RE: AIR QUALITY IMPACTS OF PROPOSED FURTHER MODIFIED PREFERRED PROJECT TO DELLARA PTY LTD V MINISTER FOR PLANNING & PENRITH CITY COUNCIL – LAND AND ENVIRONMENT COURT CLASS ONE PROCEEDINGS 10928 OF 2010 – RESPONSE TO MINISTER

"Supplementary Air Quality Assessment. Modified Preferred Project. Orchard Hills Waste and Resource Management Facility, Air Quality Assessment", 19 May 2011. Prepared by PAEHolmes on behalf of Dellara Pty Ltd.

Figure 1: St Marys OEH 24-hour average PM₁₀ concentrations 2007

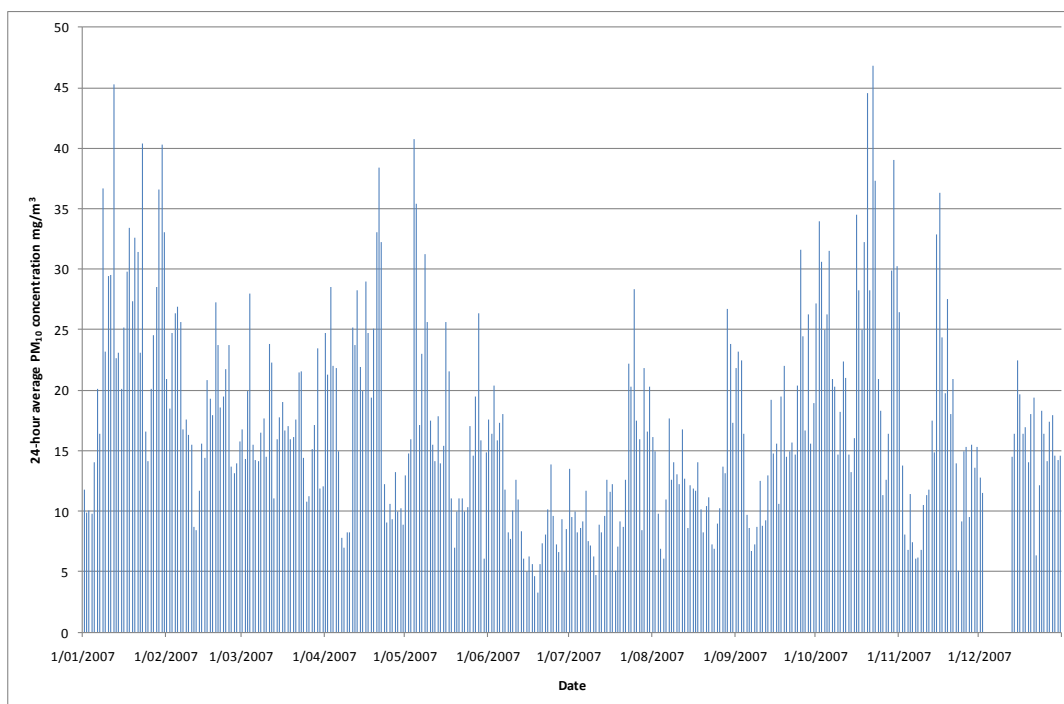
As detailed in the letter dated 22 September 2011, the Air Quality Impact Assessment (AQIA) completed for the MPPR (**PAEHolmes, 2011**) concluded that the only exceedence of the air quality criteria may occur during the construction phase when existing background air quality concentrations were included. As presented in Table 5 of **PAEHolmes 2011**, the maximum predicted 24-hour average PM₁₀ concentration at the residences due to the construction operations was 30 µg/m³. The resultant cumulative impact when existing background levels were included was 51 µg/m³ compared with the air quality impact assessment criterion of 50 µg/m³. The highest predicted impact occurred on a day when the background concentrations were elevated across the region and as such indicates some regional event (e.g. bushfire) contributed to the elevated background concentrations on that day which are not typical of air quality in the area (see Table 7 of **PAEHolmes 2011**).

Figure 1 presents the 24-hour PM₁₀ concentrations from the Office of Environment and Heritage (OEH) monitoring station located at St Marys for 2007. These data are contemporaneous with the meteorological data used in the AQIA. As these data show, almost 70% of the 24-hour average concentrations are less the 20 µg/m³. The likelihood of the worst-case impacts due to construction occurring on the same day as the worst-case background are minimal. In addition the use of a real-time air quality monitoring system will provided further protection to the residents.
